RE: 5400 Menaul Blvd NE
Grading and Drainage Plans
Engineer's Stamp Date: 11/08/21
Hydrology File: H18D074

**RE: 5400 MENAUL BLVD
GRADING AND DRAINAGE PLANS
HYDROLOGY FILE: H18D074**

Per the correspondence dated October 22, 2021, please find the following responses addressing the comments listed below:

H-18-Z

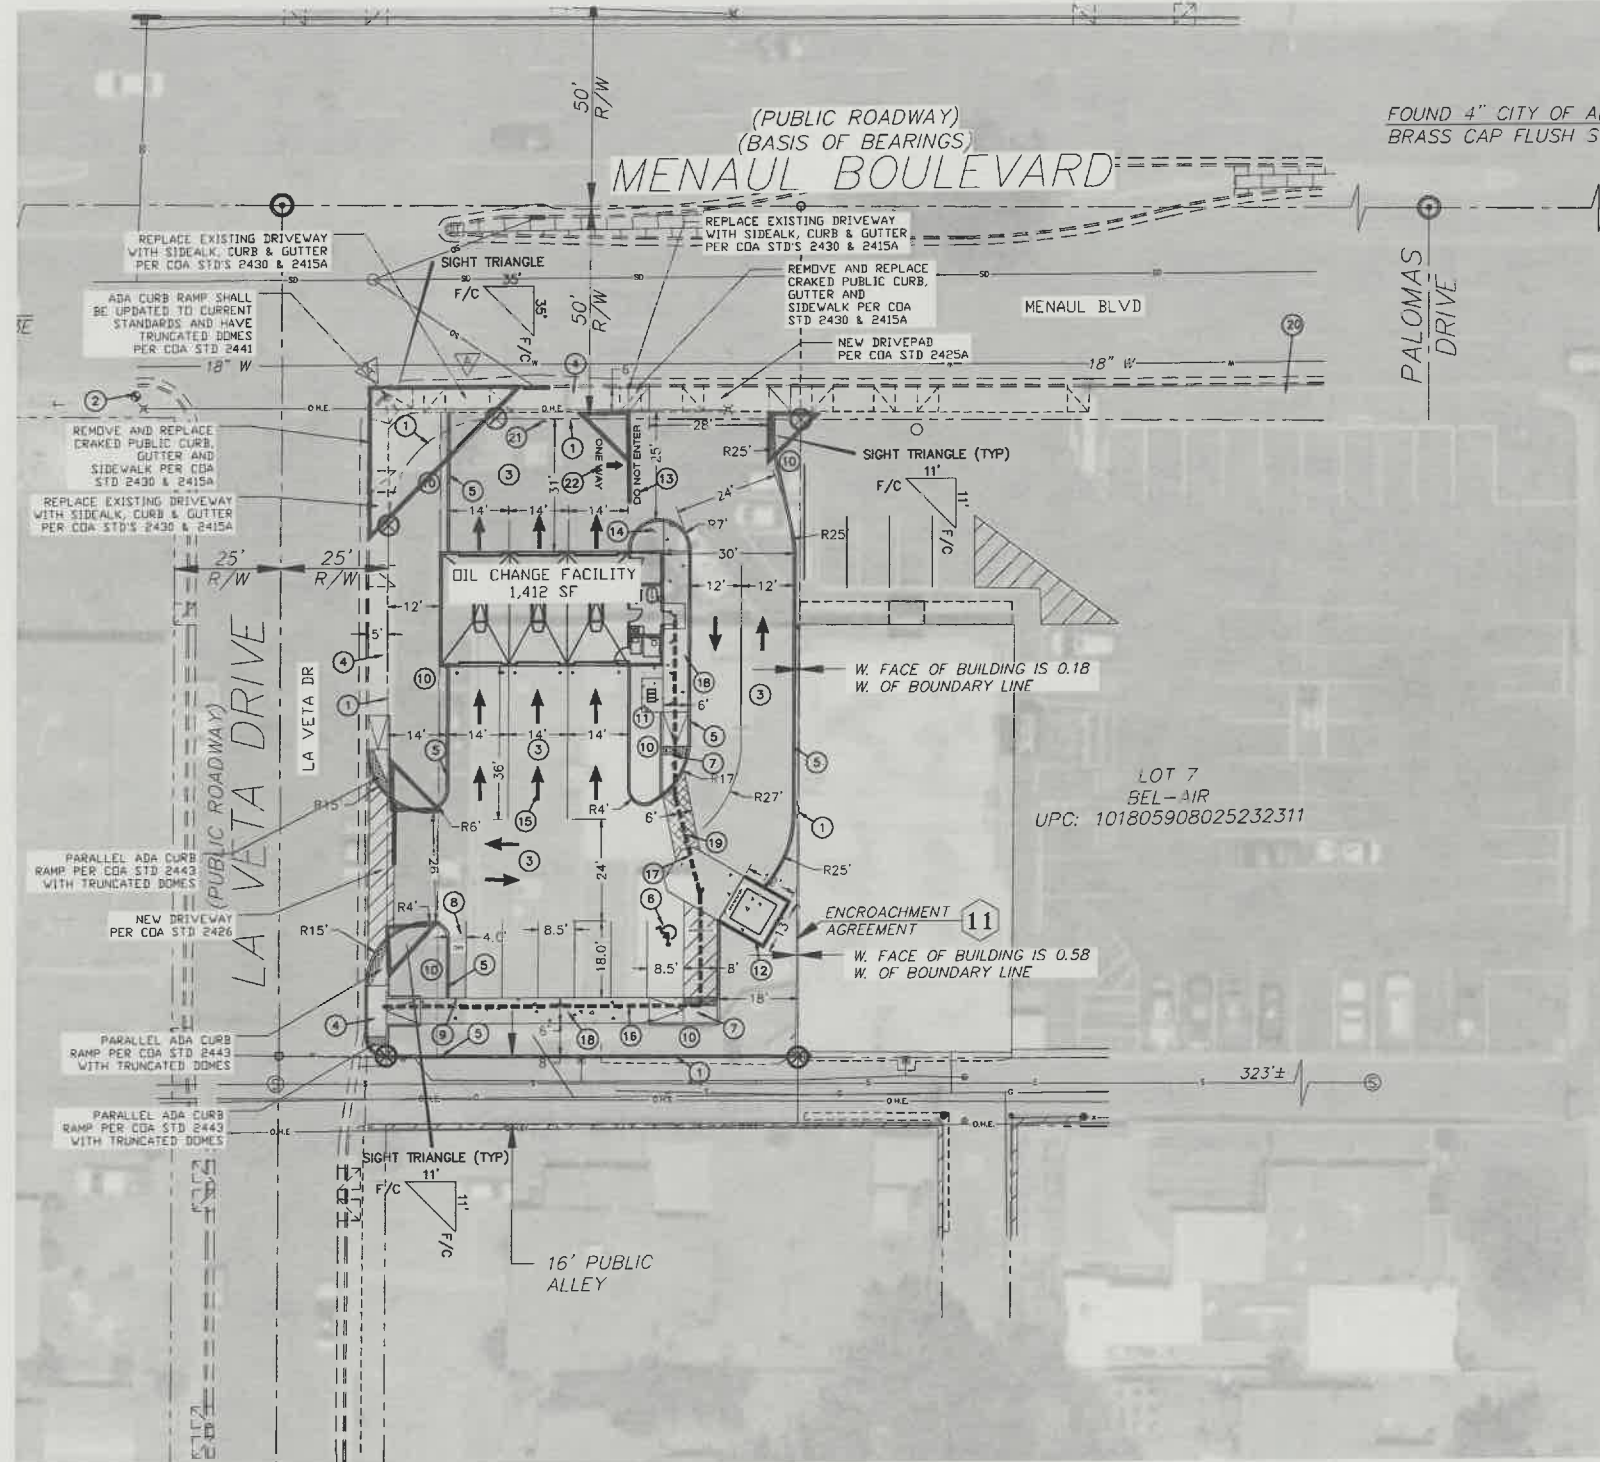
1. Please provide a vicinity map showing the location of the site. Typically this is the Zone Atlas. This can be downloaded in PDF format from the City of Albuquerque's website:

Response: Please see attached Vicinity Map.

ENGINEER'S SEAL RONALD R. BOHANNON P.E. #7868	3-BAY OIL CHANGE 5400 MENAUL BLVD NE TRAFFIC CIRCULATION LAYOUT	DRAWN BY LN DATE 08/31/2021 2021077-TCL
	TIERRA WEST, LLC 5571 MIDWAY PARK PLACE NE ALBUQUERQUE, NM 87109 (505) 858-3100 www.tierrawestllc.com	SHEET # C1 JOB # 2021077

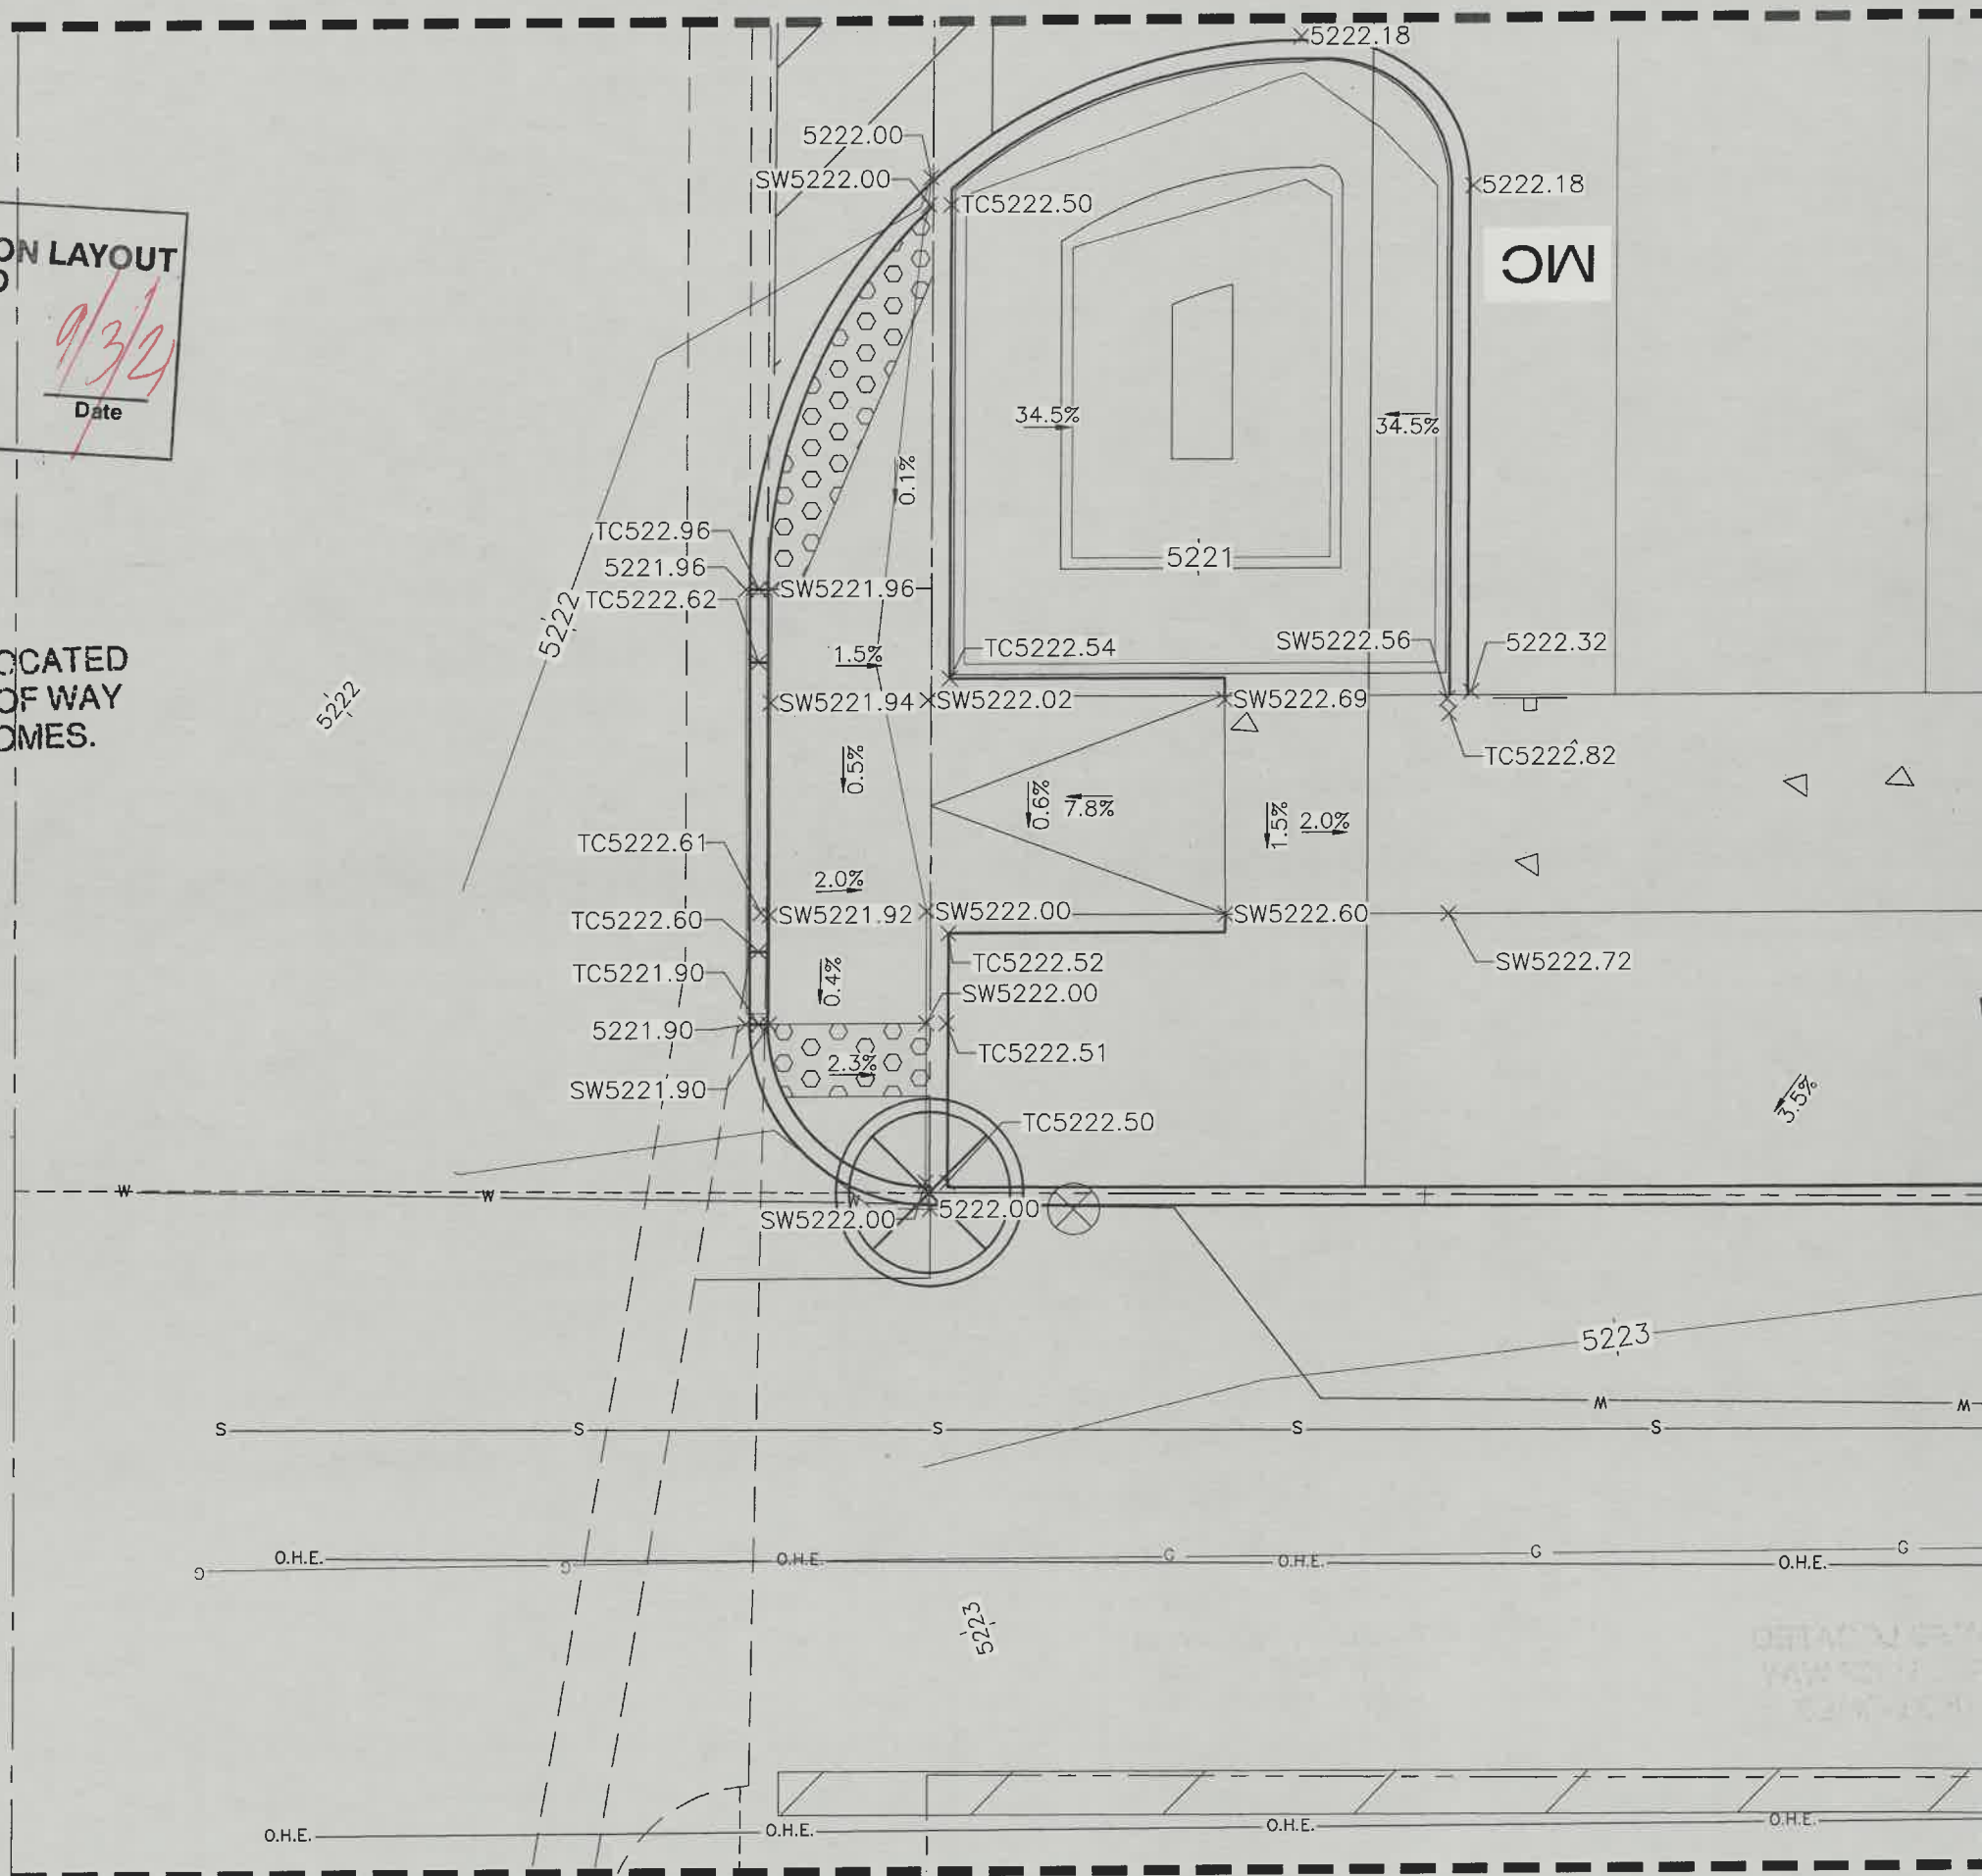
1. Please contact Transportation. There are some existing drives that need to be closed on both Menaul and La Veta. Also, the ADA Ramps may need to be brought up to current standards on Menaul.

2. Please show a label on both Menaul and La Veta where the existing drives are to be closed. This can be placed here or on C3.3

Response: Please see attached approved TCL.

Response: Please see attached approved TCL.

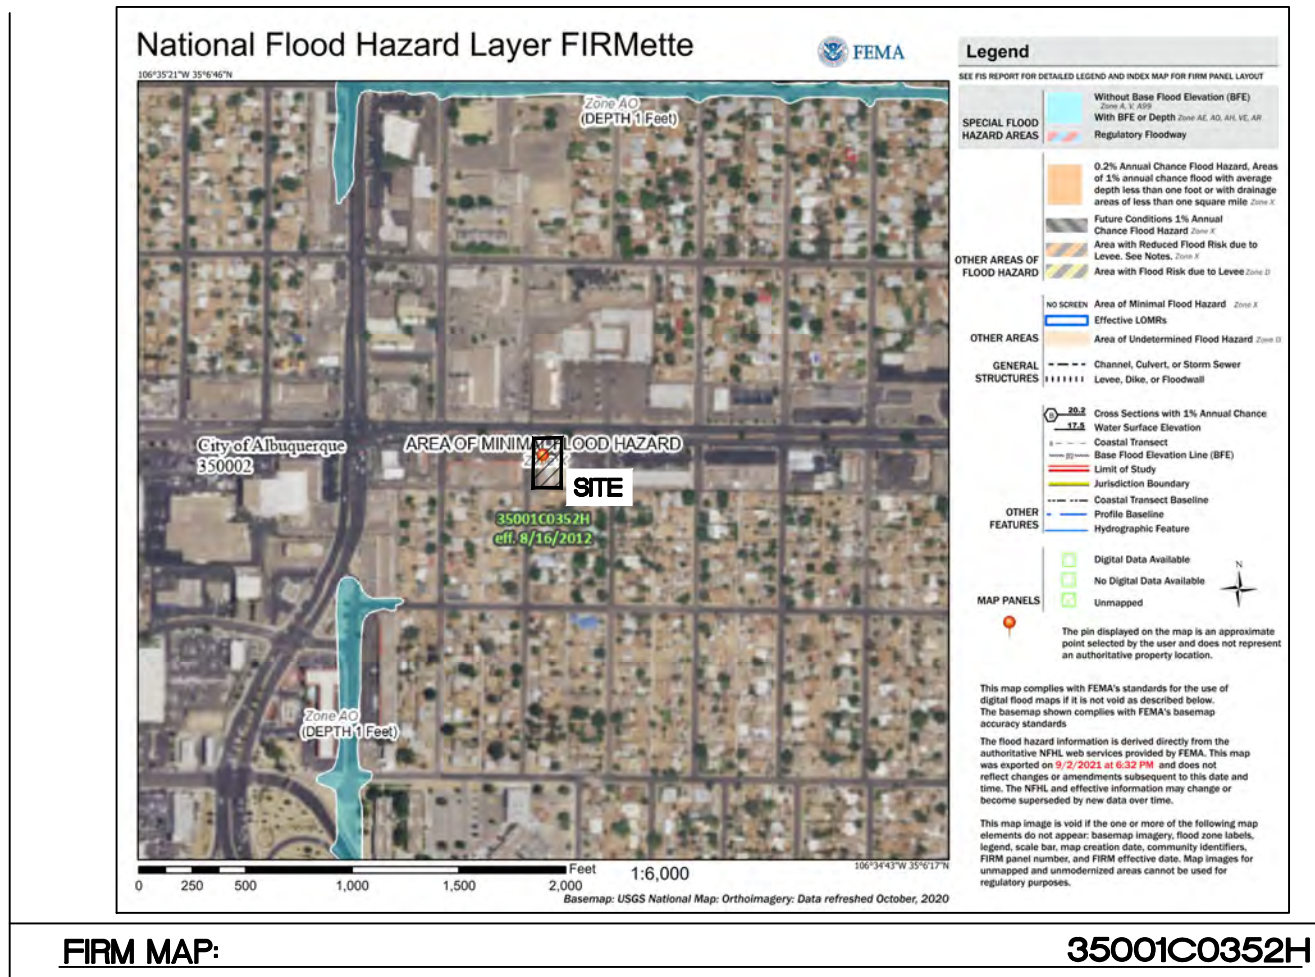
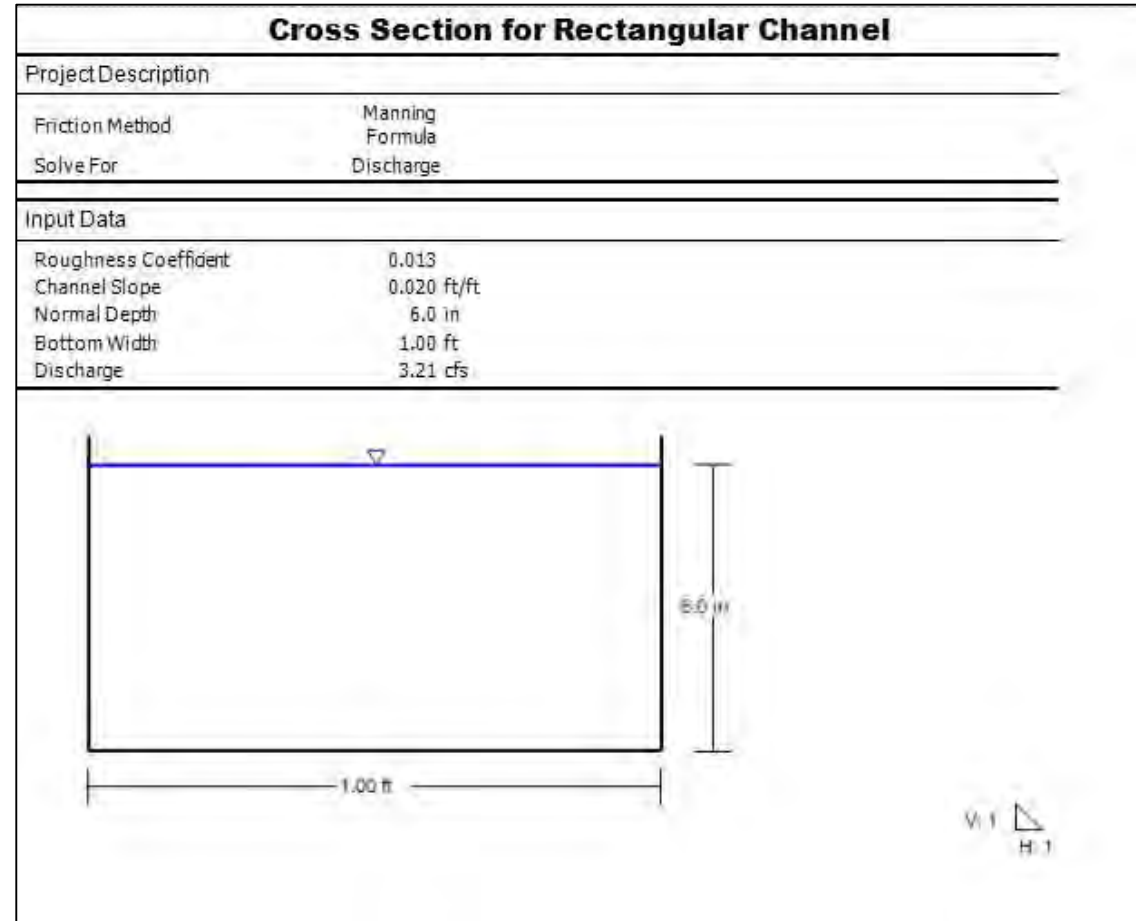
2. Please provide the weir calculations, per DPM Article 6-16(A), for the curb cuts and sidewalk culverts. A coefficient of 2.7 is typically used for the weir equation $Q=CLH^{2/3}$

Response: Weir calculation for the sidewalk culvert and curb cut added to Sheet C3.1.

Weir Equation (SIDEWALK CULVERT 1)	
Q =	CLH ^{3/2}
C =	2.7
L (ft) =	1
H (ft) =	Depth of water above center of orifice
Q (CFS) =	Flow

Weir Equation (CURB CUT 1)	
Q =	CLH ^{3/2}
C =	2.7
L (ft) =	1
H (ft) =	Depth of water above center of orifice
Q (CFS) =	Flow
